► Trio Motion Technology ◀

Technical Bulletin

Doc No.: TN20-07
Version: 1.0
Date: 25 November 1998
Subject: Serial Communication problem on MC204 without Fibre-optic interface.

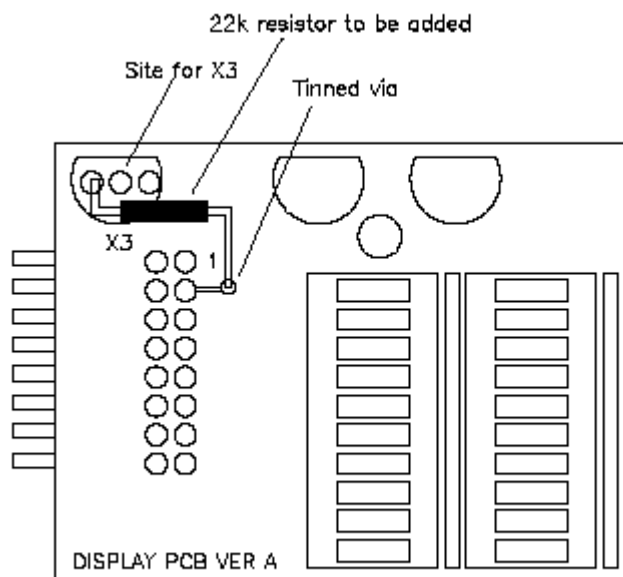
A problem has been identified which can cause occasional serial communications difficulties on port 0 and port 1 of the MC204 Motion Coordinator. *This problem only occurs on systems which are not fitted with the fibre-optic interface.*

The problem can be fixed by fitting an LED display board (P335) with an additional resistor fitted. Trio will supply these free of charge to any customers with an MC204 without the fibre-optic interface. The problem does not damage the MC204 in any way, but can affect software operation.

It is also possible to easily modify an existing LED display by the addition of one through-hole resistor:

The resistor to be added should be approximately 22k 1/4W or 1/2W type.
